Access Compliance Report

Public Rights-of-Way

(Curb Ramps)

Intersection ID: 48946	Main Street: DAVID_JENNINGS_AV	Cross Street: MITCHELL_GRANT_WY	Location: S
ADA ID: D7F64B58E745	Ramp Type: Perp	Initial Pass/Fail: Fail	Overall Compliance: No
Severity Score: 8.75			
Codes/Mitigation Info/Possible Solution		Field Measurements/Component Compliance

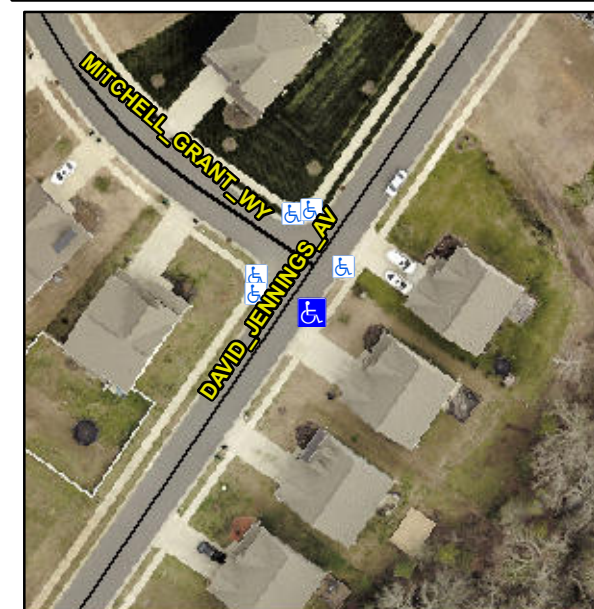
Not Found, R304.5.1

Compliance	Description	Data	Compliance	Description	Data
N/A	Ramp Length (in)	46.5	Yes	Ramp Slope (%)	6.1
No	Ramp Width (in)	47.0	Yes	Ramp XSlope (%)	1.0
N/A	Flare Type LT	N/A	N/A	Flare Type RT	N/A
N/A	Flare Slope LT (%)	N/A	N/A	Flare Slope RT (%)	N/A
N/A	Flare Traversable LT?	N/A	N/A	Flare Traversable RT?	N/A
N/A	Landing Length (in)	N/A	N/A	DWS Provided?	N/A
N/A	Landing Width (in)	N/A	N/A	DWS Contrast?	N/A
N/A	Landing Slope (%)	N/A	N/A	DWS Length (in)	N/A
N/A	Landing X Slope (%)	N/A	N/A	DWS Full Width?	N/A
N/A	Landing Curb? (Y/N)	N/A	N/A	DWS Offset (in)	N/A
N/A	Shared Landing?	N/A			
N/A	Gutter Ponding?	N/A	N/A	Gutter Slope (%)	N/A
N/A	Gutter Lip Ht (in)	N/A	N/A	Gutter X Slope (%)	N/A
N/A	Painted X Walk1?	No	N/A	Painted X Walk2?	N/A
	X Walk 1 Direction	To NW		X Walk 2 Direction	N/A
N/A	X Walk 1 Width (in)	N/A	N/A	X Walk 2 Width (in)	N/A
	X Walk 1 Slope (%)	3.6		X Walk 2 Slope (%)	N/A
	X Walk 1 X Slope (%)	1.8		X Walk 2 X Slope (%)	N/A

Remove & Replace Entire Ramp.
